The FirstEnergy Nuclear Operating Company (FENOC) docketed a May 2, 2007, letter responding to four specific issues raised by the NRC staff regarding the Exponent Failure Analysis Associates' technical report, "Review and Analysis of the Davis-Besse March 2002 Reactor Pressure Vessel Head Wastage Event." In the May 2nd letter, FENOC noted that they provided the Exponent report to NEI with a request that an evaluation be conducted to determine if the report calls into question the adequacy of the industry's operational monitoring or inspection programs or otherwise raise a potential generic safety concern.

**Effect of Exponent Analysis of
Davis-Besse Reactor Vessel Head Wastage Event
On Industry Inspection Programs**

NEI commissioned an expert panel to review the First Energy Nuclear Operation Company (FENOC) report of December 15, 2006, authored by Exponent, entitled "Review and Analysis of the Davis-Besse March 2002 Reactor Pressure Vessel Head Wastage Event" to determine the potential impact on industry inspection programs for reactor vessel top head nozzles. The two main questions addressed by the panel and conclusions are as follows:

Figure 2-1
Davis-Besse Crack Growth Rates Relative to MRP-55 Data

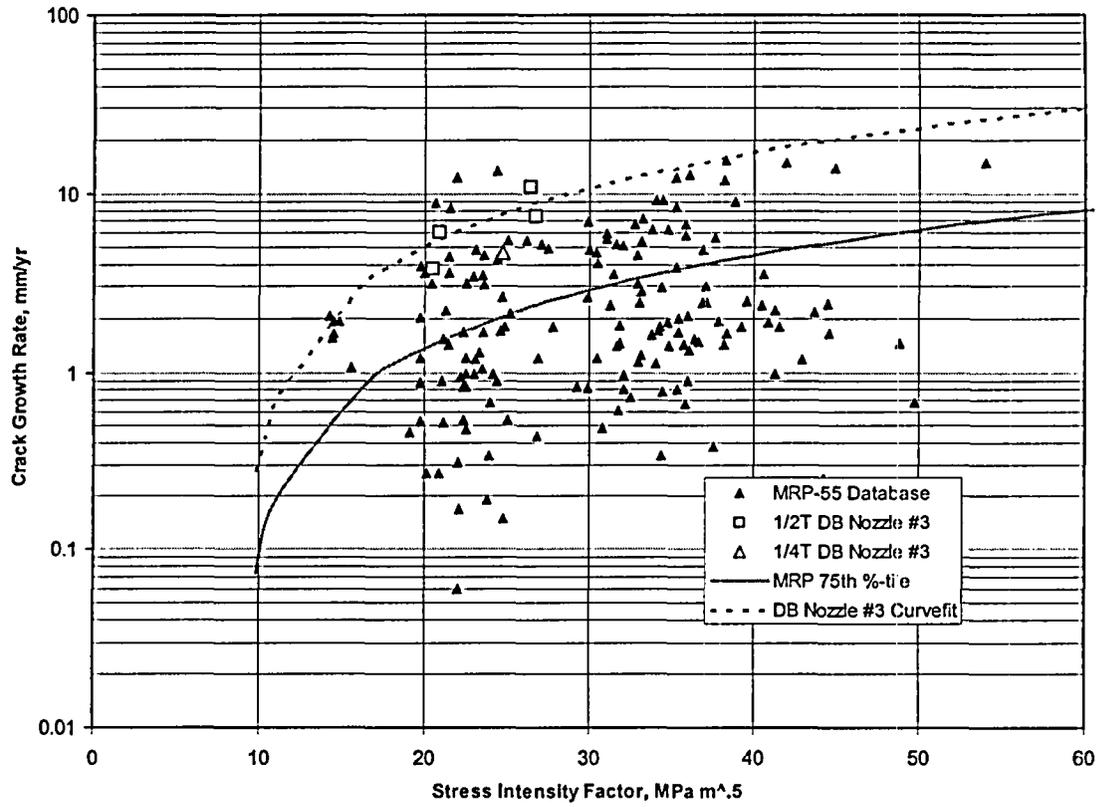
Exponent states that the crack growth rates of the Davis-Besse CRDM nozzle material were up to four times the growth rate of the MRP recommended 75th percentile crack growth curve reported in MRP-55. While this statement is correct, Figure 2-1 from MRP-55 shows that some of the material specimens in the MRP-55 database had crack growth rates even higher than the Davis-Besse material. Therefore, the Davis-Besse material is considered to be within the bounds of previously evaluated materials.

Figure 2-2
Projected Crack Growth and Industry Examination Requirements for a High Temperature Head under Crack Growth Rate Conditions Postulated in Exponent Report

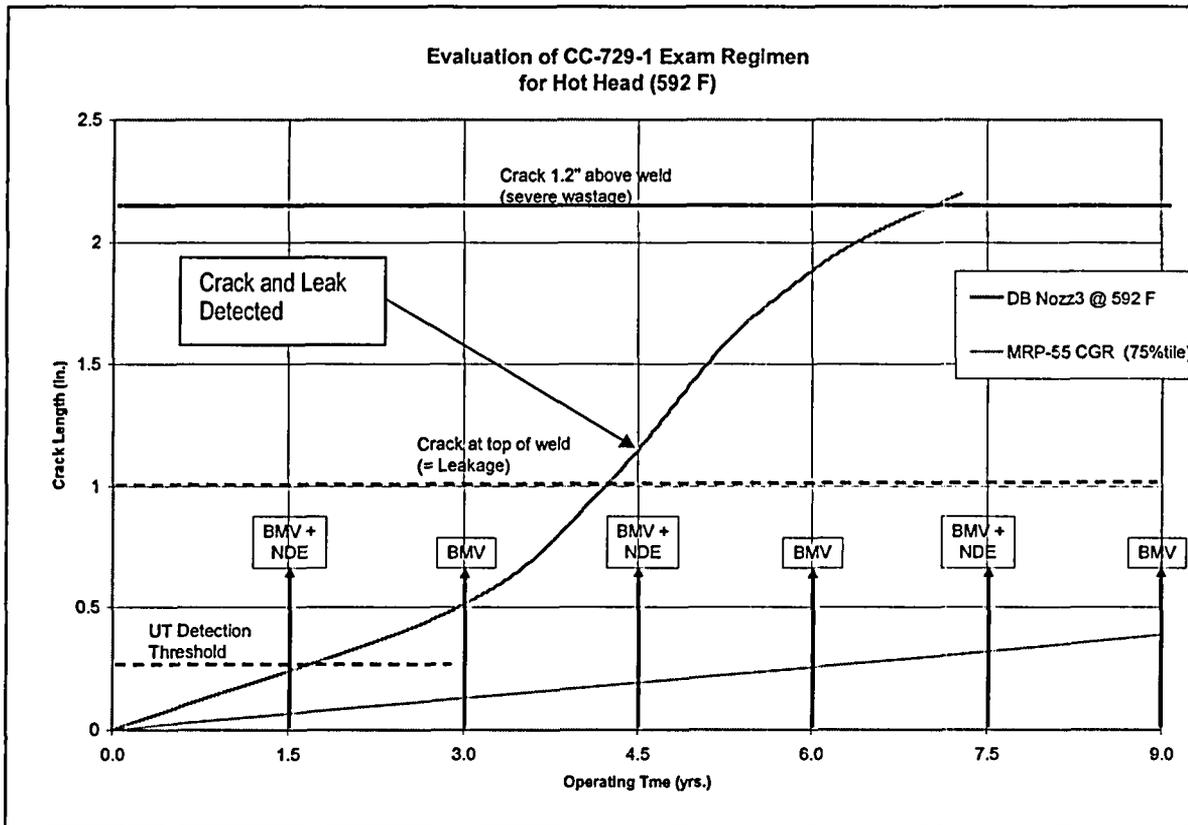
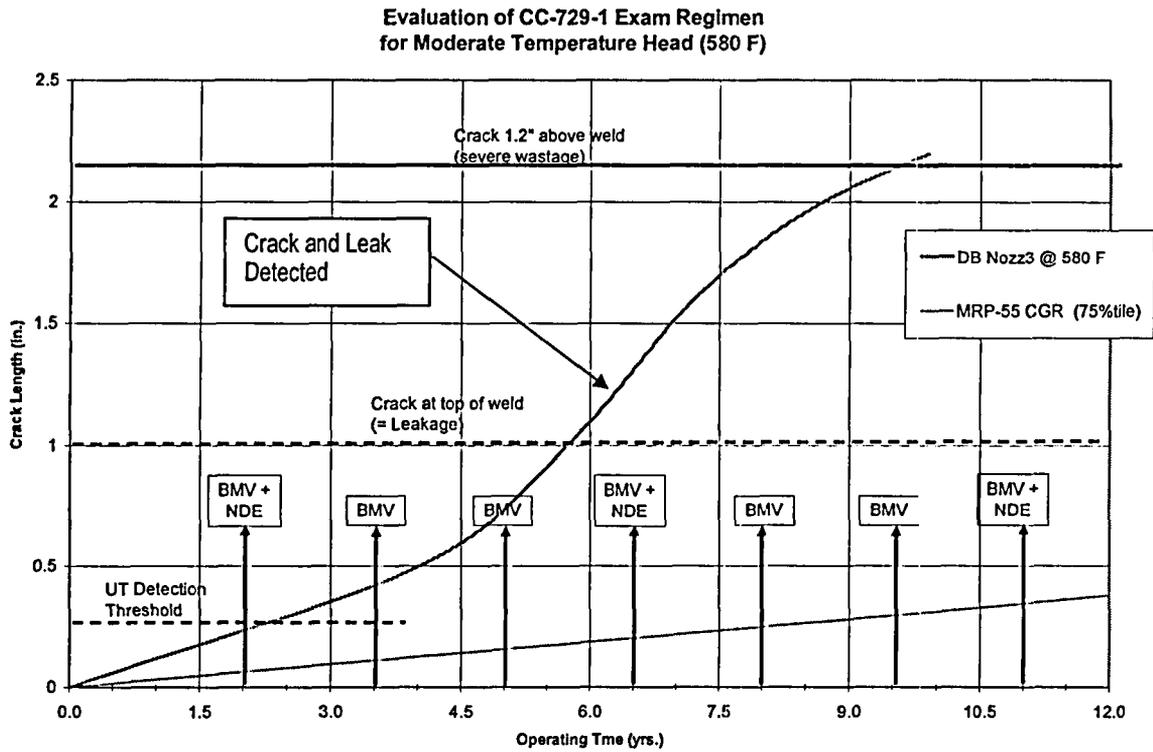
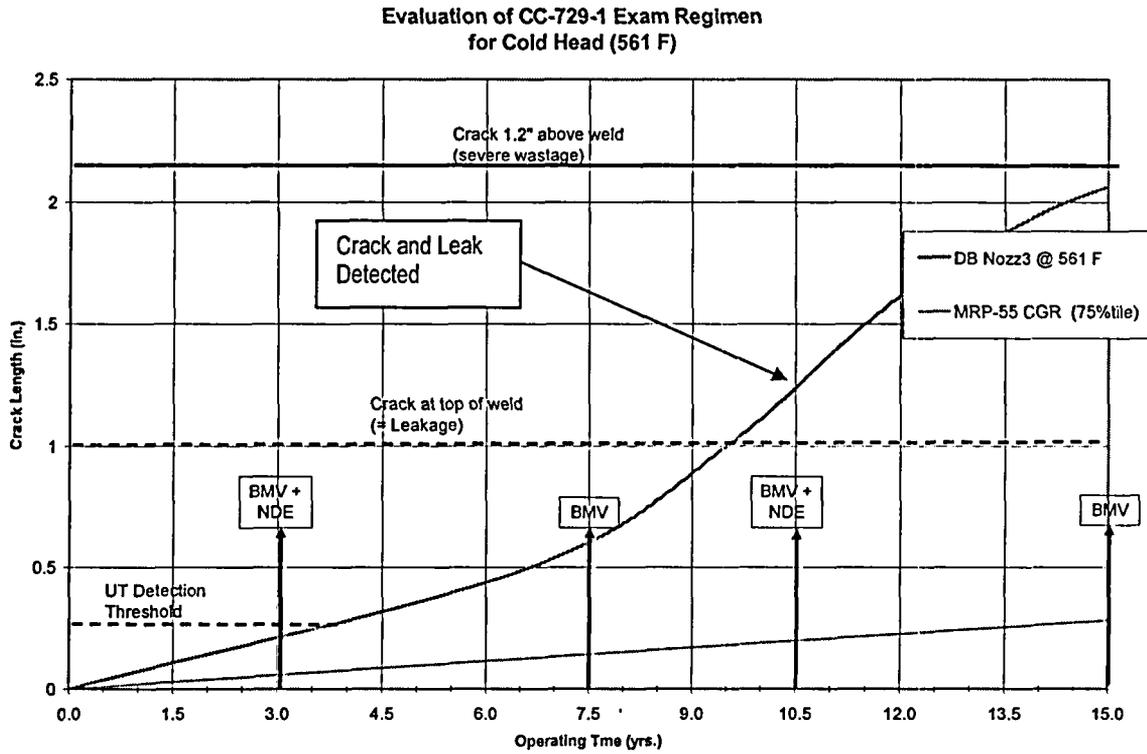
Deterministic predictions of crack growth for the three sample cases, using the crack growth rate curve for Davis-Besse Nozzle 3 referenced in the Exponent report are presented in Figures 2-2, 2-3 and 2-4. In each case, the crack growth rate equation was adjusted to the appropriate head operating temperature in accordance with the Arrhenius equation for crack growth (MRP-55¹). The figures also show the predicted crack growth in accordance with the MRP-55 75th percentile crack growth law for comparison purposes. Several significant crack sizes are shown as horizontal dashed lines on the figures, corresponding to the crack length at which detection by UT would be expected with high confidence (conservatively assumed = 0.25"), the crack length corresponding to the crack at the top of the weld, at which leakage is predicted, and a crack length of 1.2" above the weld, corresponding to the crack length that was discovered at Davis-Besse in 2002. Finally, vertical arrows are plotted on the figures corresponding to the NDE and BMV inspections that would be required at various refueling outages, per Table 2-1 above. Since inspections required per the NRC Order are somewhat more conservative than those required by Code Case N-729-1, only those required per the Code Case are shown on the figures. This produces the most conservative evaluation of the potential effect of the Exponent crack growth rate, since it corresponds to the least amount of inspection that would possibly be performed in the future. Also for conservatism, the initial baseline inspection was assumed to occur at a time when the postulated crack is just below the UT inspection threshold, and would thus be missed.

Figures 2-2 through 2-4 show that for each hypothetical case an NDE + BMV would be performed shortly after the postulated cracks are projected to reach the top of the welds, such that they would be well above the detection threshold of the ultrasonic NDE, and evidence of leakage would likely be detected by the BMV as well. These exams would be performed, and the cracking detected, well before the crack length approached the size predicted to have caused the severe wastage observed in the Davis-Besse head. These results, plus the conservative bounding nature of the deterministic evaluation, were a major factor in the panel's conclusion regarding adequacy of the current industry RPV top head examination program.
